**WRITTEN STATEMENT OF TOM MYERS, PhD  
On Behalf of Turner Ranch Properties, LLP and Hillsboro Pitchfork Ranch, LC**

**Before the Mining and Minerals Division of the  
New Mexico Energy, Minerals & Natural Resources Department  
on the Application of New Mexico Copper Corporation for a  
Permit to Operate the Copper Flat Mine in Sierra County, New Mexico**

## II. COMMENTS ON PERMIT APPLICATION

Figure 3: Projected post-mining drawdown in the crystalline bedrock around the proposed pit at the Copper Flat Mine (Source: Figure 3.1 from Jones and Finch (2018))

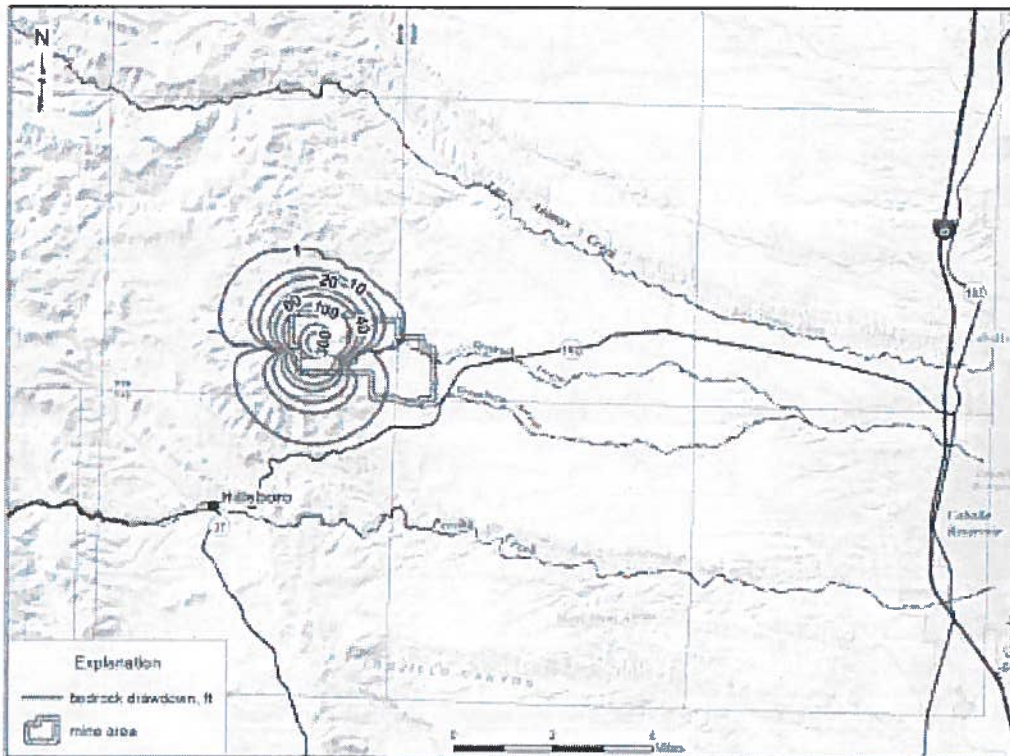
Figure 3 shows the simulated post-mining (ca 2030) drawdown around the larger proposed pit. Drawdown does not represent the capture zone because not the entire drawdown cone is drawn to the pit. Drawdown on the water table where it initially slopes away from the pit only decreases the gradient for flow away from the pit. Portions of the aquifer that experience drawdown could still have a gradient away from the pit. Superimposing the drawdown in Figure 3 with the potentiometric surface in Figure 2 shows the capture zone. It is not possible to show the actual postmining capture zone prior to expansion of the pit, but it is apparent the capture zone would be much larger than currently exists. For example, the position of the 100-foot contour indicates that drawdown (Figure 3) will extend beyond the permit boundary in an area the potentiometric surface is flat, other than the existing capture zone as described above (Figure 2). This expanded capture zone will pull groundwater from farther away in the aquifer, thereby changing the hydrologic balance of the aquifer. Less flow will pass the area influenced by dewatering. Consequently, the water bodies currently fed by groundwater flow will have less groundwater flowing to them. NMCC should have used its model to show the extent of the capture zone and to estimate the amount of water drawn into the influence of the pit.

Further, dewatering the pit and the development of the pit lake in the long-term will affect flows to and in Las Animas Creek and Percha Creek by diverting flow that would otherwise be toward those creeks. The 2011 potentiometric surface (Figure 2) shows a groundwater plateau from the project area to the west, with steep contours both north and south from the plateau. These contours reflect a flow gradient away from the general west to east flow path and towards the streams. The plateau may be due to the lower conductivity of the crystalline bedrock (monzonite and andesite) near the proposed pit (Figure 1) which diverts groundwater both north and south. That groundwater flow currently supports springs which feed the two creeks, including springs in the Las Animas Creek canyon and in tributary canyons. Dewatering will cause drawdown (Figure 3), which will reduce the flow gradient to those springs and divert

groundwater flow away from the north and south by drawing it toward the pit. This may be seen by superimposing the drawdown (Figure 3) on the preexisting potentiometric surface (Figure 2). If the andesite/monzonite near the pit has a higher conductivity than that assumed by Jones et al (2014), the drawdown could extend farther to the north and affect the flows in the springs and Las Animas Creek even more.

Dewatering drawdown will affect the groundwater level at wells on both the Ladder and Hillsboro Pitchfork Ranches. Figure 3 shows that at the end of mining the drawdown would extend across permit boundaries into private and public land north, west, and south of the project. Figure 4 shows that groundwater would be drawn toward the pit from up to two miles south and north of the pit. Drawdown would be 60 feet at the southwest corner of the project boundary and would exceed one foot at up to 1.5 miles of the permit boundary onto the Hillsboro Pitchfork Ranch. This would possibly affect the Rodgers Well and Grayback Well on the Hillsboro Pitchfork Ranch. Drawdown exceeds 100 feet at the north project boundary and would also exceed 1 foot for up to the 1.5 miles beyond the permit boundary and into the Ladder Ranch. This would likely affect the Myers Well, John Cross Well, and Evans Well. As noted in the previous paragraph, a conductivity higher than assumed by Jones et al (2014) would allow the drawdown to affect even more wells further into the Ladder Ranch.

Well GWQ-5R is just south of Grayback Arroyo in the middle of Figure 4. It is within the 1 to 10-foot drawdown contour shown on Figure 3. Lowering the water level in the andesite would decrease or reverse the gradient for flow to the arroyo and remove a source of water to the alluvium in the arroyo, and affect riparian vegetation and hydric soils that existing within the arroyo.

Figure 5: End of mining drawdown in the Santa Fe Group aquifer due to mine operations. (Source: Figure 3.1 from Jones and Finch (2018))

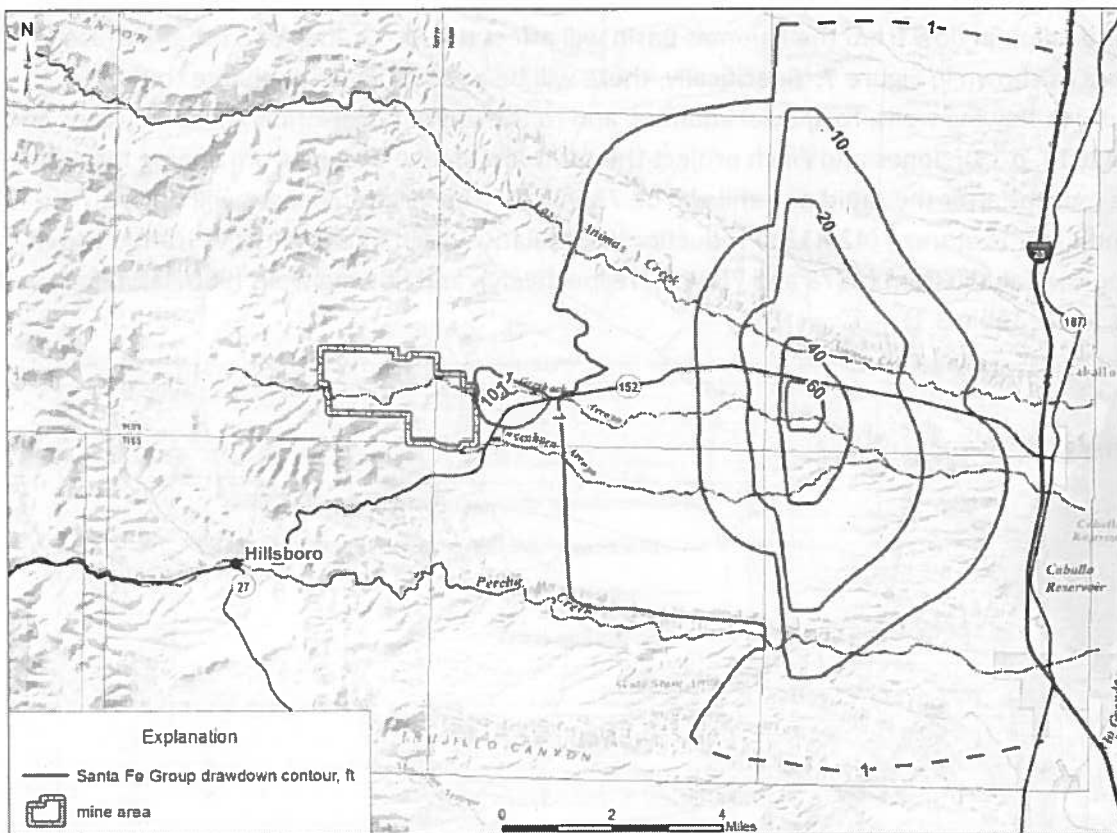
The pumping will upset the balance of groundwater flow in the Palomas Basin and discharge into the Caballo Reservoir. Figure 5 shows the extensive drawdown at the end of mining that would occur in the Santa Fe Group, the source for the production water. The extent of the drawdown shows that production pumping will affect groundwater flow over a large area, with the north-south dimension of the 10-foot drawdown being about 10 miles. Pumping will draw primarily from aquifer storage, with the rate of removal as high as 6000 af/y, declining to less than 3000 af/y by the twelfth year, the end of mining (Figure 6). By that time, the pumping will be drawing about 600 af/y from north Palomas Graben aquifer (see the area north of the Palomas Basin in Figure 1), and it will reduce the flow from the Palomas Basin by more than 3000 af/y (Figure 6). The reduction in discharge from the basin will continue for decades, although its substantial effects will last for about 30 years beyond the end of mining (as the discharge reduces to less than 10% of its previous amount). The continued reduction beyond the end of mining is due to groundwater entering storage to replenish the deficit caused by pumping, the drawdown.

Figure 7: Projected reductions in discharge (Source: Figure 3.3 from the PHCC (Jones and Finch 2018))

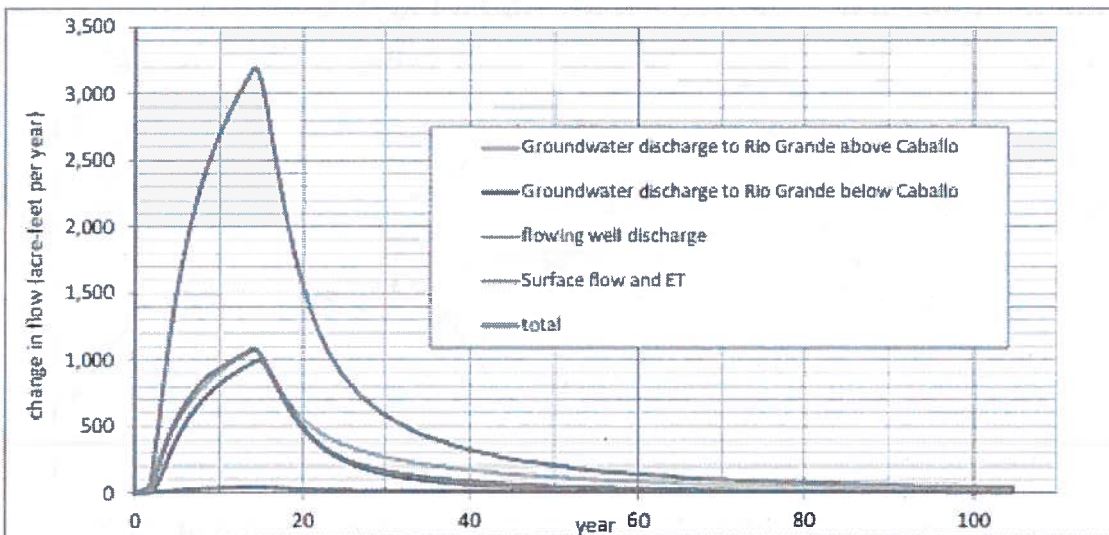
The reduction in flow from the Palomas Basin will affect the Rio Grande and other surface sources as shown in Figure 7. Specifically, there will be a reduction in discharge to the Rio Grande, to flowing wells, to alluvial aquifers, and to the Animas Creek riparian zone (Jones and Finch 2018, p 13). Jones and Finch project the total cumulative change from mining through three months after the rapid pit refill will be 73,987 af. The largest changes will be to groundwater in storage (42,813 af reduction), cumulative discharge to the Rio Grande above and below Caballo Dam (8878 and 7504 af, respectively), and flowing wells (9007 af) (Finch and Jones 2018, Table 3.1).

Pumping the production wells will also decrease the discharge from flowing artesian wells along the lower Animas Creek and Percha Creek (Jones and Finch 2018, p 17, 18). The pre-mining discharge is 2030 af/y and production pumping would reduce that to 1054 af/y, as shown in

Figure 9: Time series plot of predicted sulfate for the future pit lake, for reclaimed and unreclaimed conditions. (Source: Figure 6-15 from SRK (2018)).

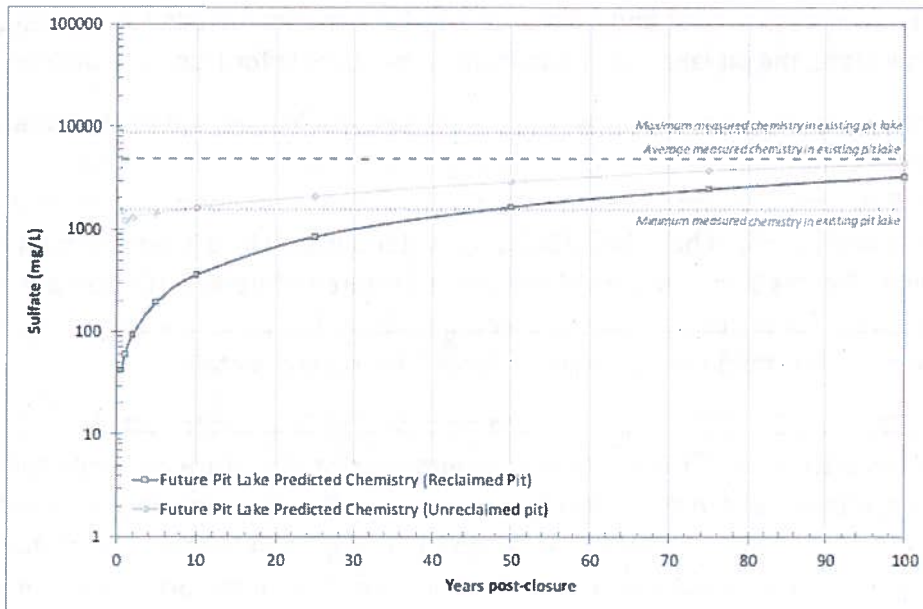
One hundred years after the end of mining, the pit lake would have sulfate and total dissolved solids (TDS) concentrations of 4353 and 6786 mg/l, respectively, for the unreclaimed pit (SRK 2018, Table 5-4) and 3258 and 5239 mg/l, respectively, for a reclaimed pit (SRK 2018, Table 6-4). The reclaimed pit would have had 2200 af of water pumped into it over six months after the end of mining. Figures 9 and 10 show the projected future sulfate and TDS concentrations with time, respectively, for the reclaimed and unreclaimed pit. The pit lake water quality would violate surface water standards as shown in Table 1 for several metals.

Velasquez (2017, p 4-24, -25) compares these predicted pit lake water contaminant concentrations with those at the existing pit lake to suggest the future condition will be an improvement with respect to the hydrologic balance and therefore in compliance with the Mining Act (19.10.6.603.C(4) NMAC). They even claim long-term evapoconcentration of the water will not cause the pit lake to be out of compliance. Even if the premise of comparison with the existing pit lake is accepted, the conclusion that evapoconcentration would not cause standards to eventually be violated is wrong because the concentration of sulfate and TDS will increase in perpetuity because the chemistry would be conservative, meaning no removal of salts from the pit lake. Figures 9 and 10 show that the predicted concentrations would continue to increase with time.

Figure 11: Layout of the proposed Copper Flat Mine. (Source: Draft Environmental Impact Statement

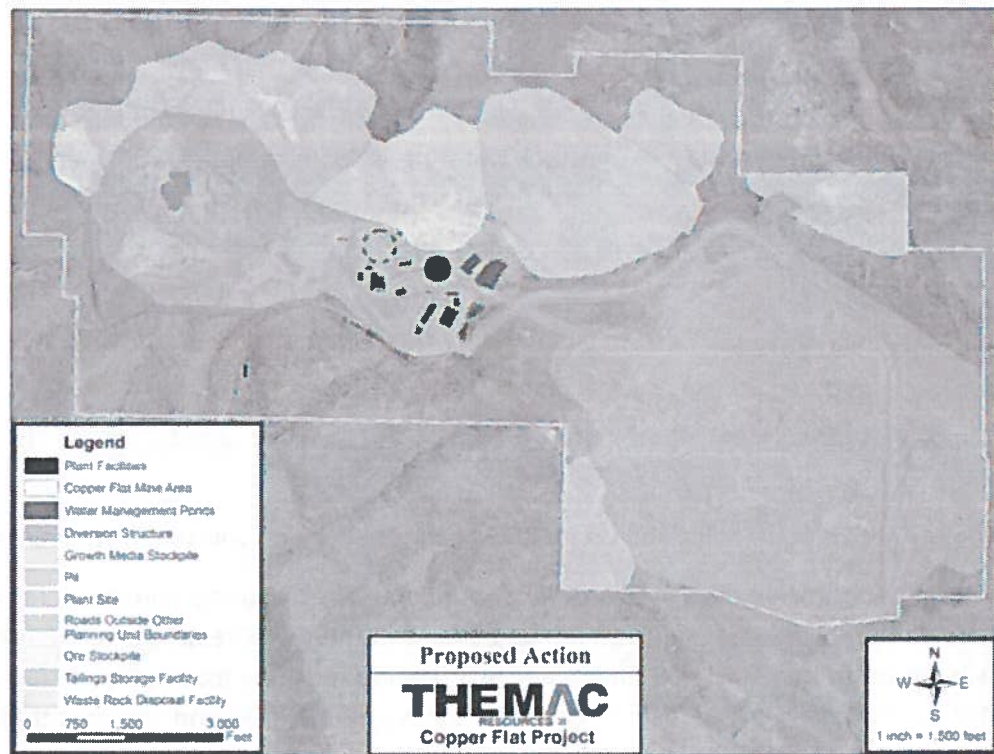
Figure 11 shows the layout of mine facilities. The proposed tailings storage facility, shown in Figure 11 as the large blue area on the southeast portion of the mine area, lies primarily on Santa Fe Group formation, which has relatively high conductivity (Jones et al 2014). Jones and Finch (2018) account for only the flow through pinhole leaks, estimating a total leak rate of 0.5 gpm over the entire tailings facility. However, leaks resulting from tears and defects in liners, occur frequently, as has been observed at many mine sites (Beck et al 2009, Breitenbach and Smith 2006, Giraud and Bonaparte 1989).

The waste rock piles, shown in orange on Figure 11, lies in the northcentral portion of the site and north of the pit (shown in red), mostly on andesite. The andesite has relatively low conductivity, but not as low as assumed by NMCC (Jones et al 2014, Jones and Finch 2018). Several lines of evidence indicate that the conductivity of the andesite is much higher than  $10^{-6}$  centimeters per second (cm/s), the conductivity that NMCC assumes in its application.

Figure 12: Injection rate results of the pressure injection test for well GWQ-5R. (Source: Figure 2 from Shomaker (2011))

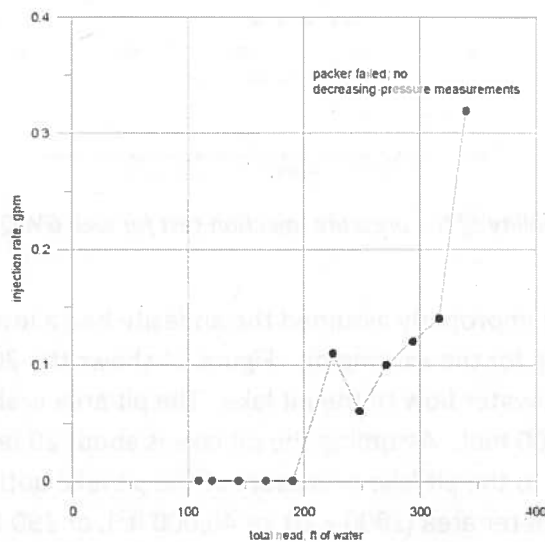
First, NMCC bases its low conductivity estimate primarily on a test at one well (well GWQ 5-R) developed in andesite described in Shomaker (2011). This test is not accurate or representative for several reasons. One is the test was performed on a well bore open interval from 64 to 100 feet below ground surface (bgs) and below the water table. Conditions at this level do not reflect conditions at the ground surface, which are likely much more weathered.

The test was a pressure injection test, known as a standard Lugeon test, which is a geotechnical method commonly used to estimate the permeability of a foundation. Simply described, the test involves collaring an open interval so that water injected into that interval can only flow into the formation surrounding the interval. The flow rate necessary to maintain pressure

within the interval with increasing pressure depends on the conductivity of the formation. The conductivity required to maintain an injection rate of 1 liter per minute (LPM) per meter of open interval is a Lugeon unit and equal to  $1.3 \times 10^{-5}$  cm/s. Figure 11, showing the injection rate and applied total head of water, shows that water began to move into the formation at about 200 feet of head and that from about 200 to 320 feet of head the injection rate ranged from about 0.05 to 0.14 gpm. The relatively constant flow between 200 and 320 feet shows that flow was laminar and Darcy's Law applies to the estimate of permeability. The permeability necessary to maintain 0.04 to 0.1 Lugeon units (Figure 12) ranges from  $5.2 \times 10^{-7}$  to  $1.3 \times 10^{-6}$  cm/s.

Figure 14: Groundwater contours for the water table near the existing pit lake. (Source: Figure 5.21 from Jones et al (2014)).

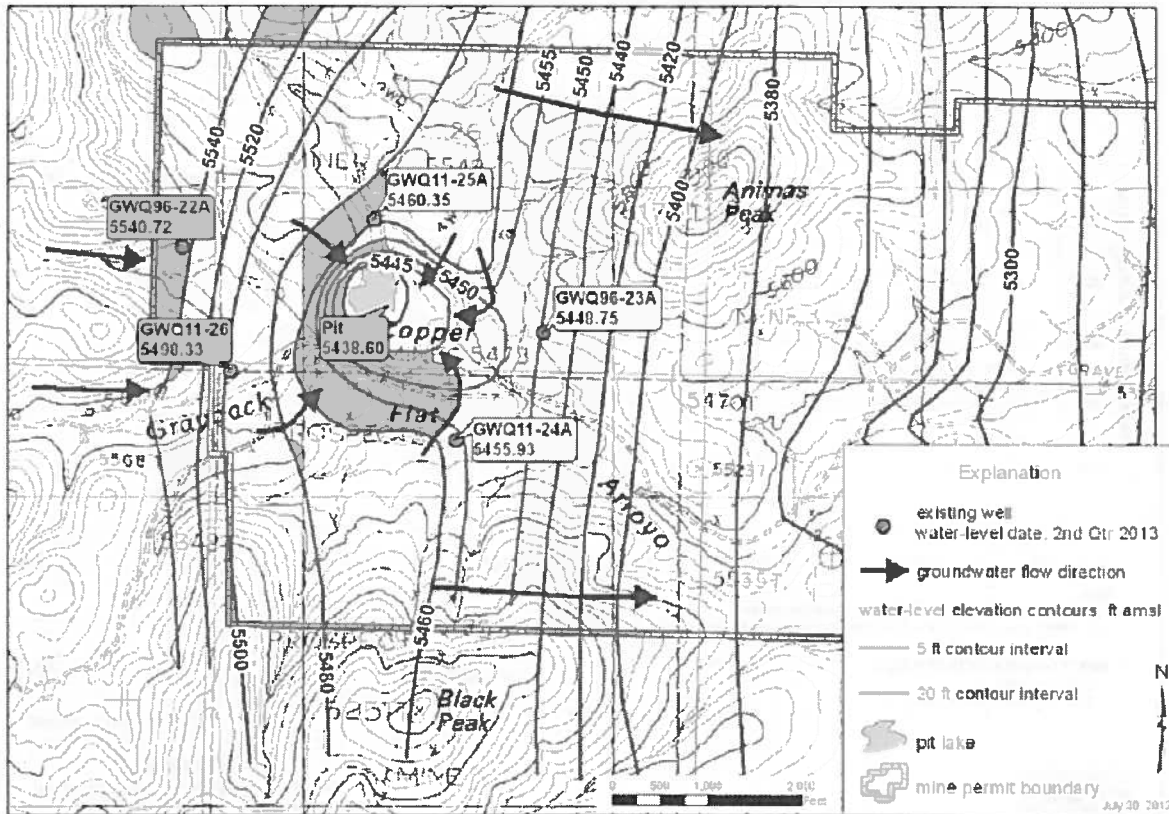
Second, Jones et al (2014) improperly assumed the andesite had a low conductivity based on observed mine dewatering for the existing pit. Figure 14 shows the 2011 potentiometric surface controlling groundwater flow to the pit lake. The pit area is about 500 by 500 feet and the perimeter is about 2000 feet. Assuming the pit lake is about 20 feet deep, the area through which groundwater flows to the pit lake is the sum of the pit lake bottom (500 x 500, or 250,000 ft<sup>2</sup>) and the perimeter area (2000 x 20, or 40,000 ft<sup>2</sup>), or 290,000 ft<sup>2</sup>. The gradient from the east is 0.01 (5 ft in 500 ft), from the west is 0.0333 (10 ft in 300 ft), from the north is 0.025 (10 ft in 400 ft) and from the south is 0.0167 (10 ft in 600 ft). Estimating gradient as the average gradient from four directions, the effective gradient is 0.02125.

For groundwater inflow rates equal to 6 and 10 gpm, K is 0.19 and 0.31 ft/d, respectively, or  $6.61 \times 10^{-5}$  or  $1.10 \times 10^{-4}$  cm/s, respectively. These rates are 66 to 110 times the rate NMCC assumes for the andesite under the waste rock, or  $10^{-6}$  cm/s.

Figure 15: Changes in sulfate and total dissolved solids in well GWQ96-22A. (Source: Figure 8-22 from Intera (2012)).

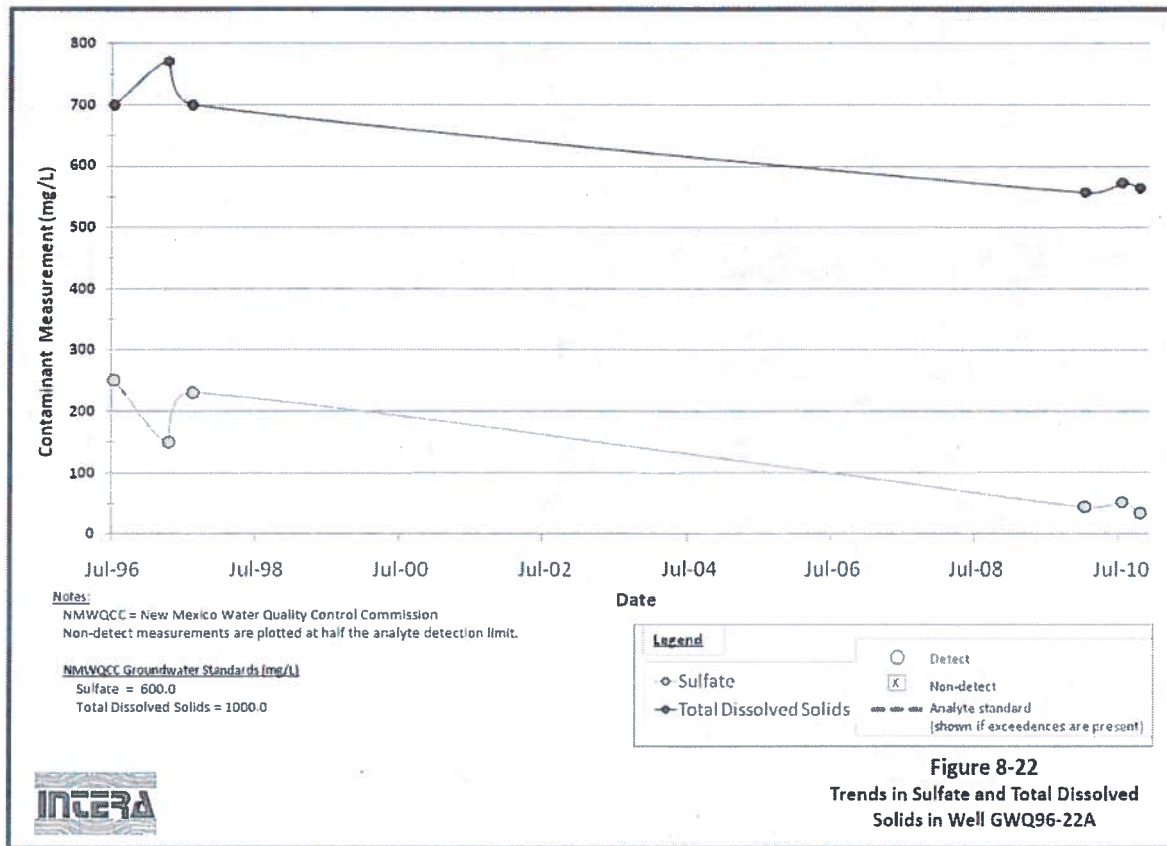
Third, wells developed in andesite show changes in water chemistry that could occur only with substantial movement of groundwater through the formation. Well GWQ96-22, developed in andesite west of the pit, shows a 27% change in TDS and about 50% in sulfate with time (Figure 15). It is not possible to estimate  $K$  from this observation, but these changes would not occur if there was not a significant flow of groundwater through the formation.

*Figure 16: Relation of permeability with the scale of measurement for the Racine Formation of the carbonate aquifer of southeastern Wisconsin. (Source: Figure 6 from Schulze-Makuch et al (1999)).*

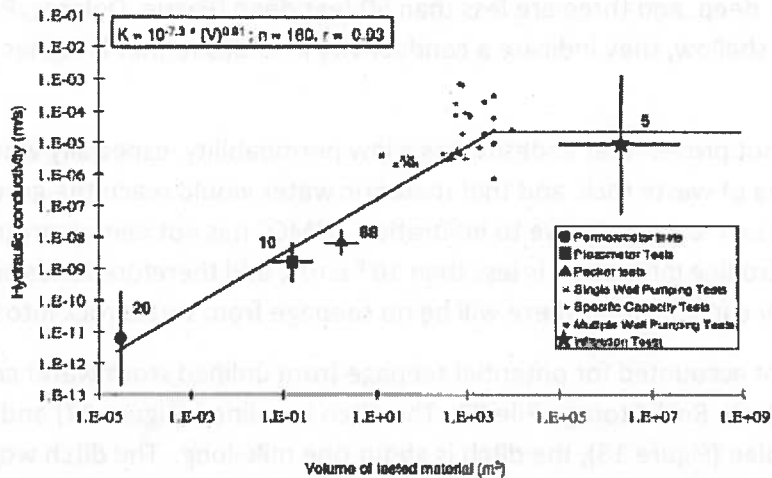
Fracture flow systems, such as at Copper Flat, have the largest variability of conductivity with measurement volume. Figure 16 shows the relation for a fracture flow media described as a “rock matrix [that] is so tight that only an insignificant amount of flow is transmitted by the

matrix" (Schulze-Makuch et al 1999, p 911). The media fractures are both primary fluid pathways and storage locations. As the volume of material considered increases, the chance of including a pathway also increases, which increases the effective K (Figure 16). The assumed K of  $10^{-6}$  cm/s ( $10^{-8}$  m/s) corresponds to a tested material volume of about  $1 \text{ m}^3$  on Figure 15. The relation of K and tested volume becomes horizontal at about  $10^{-5}$  m/s (equivalent to  $10^{-3}$  cm/s), suggesting that a larger volume could be as much as 1000 times more conductive than NMCC assumes for the andesite. This occurred at a volume of about  $500 \text{ m}^3$ , which is much larger than the volume likely associated with the area around a bore hole subjected to a pressure test.

Scale effects make it apparent that conductivity from a short-term pressure test that applies very near the borehole is generally less than conductivity from a volume more applicable to conductivity controlling flow and transport beneath the waste rock.

Figure 17: Cross-section of stormwater conveyance ditch near Waste Rock Storage Pile #3. (Copper Flat Project, Impoundment Design Report, 2015)

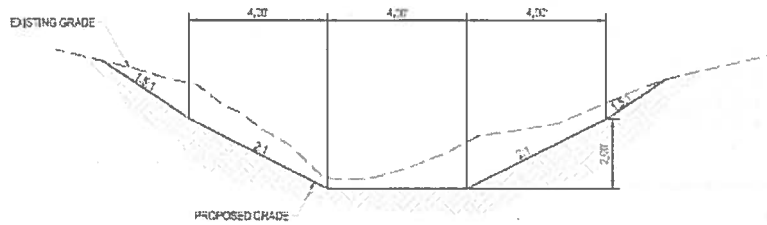
NMCC has also not accounted for potential seepage from unlined stormwater conveyance ditches around Waste Rock Storage Pile #3. The ditch is unlined (Figure 17) and based on scaling from the plan (Figure 18), the ditch is about one mile long. The ditch would capture water running from the waste rock. The water would have contacted waste rock, and therefore could convey contaminants. Because the ditch is unlined, the impacted water could enter the groundwater beneath the waste rock pile, especially wherever the ditch crosses a conductive zone.
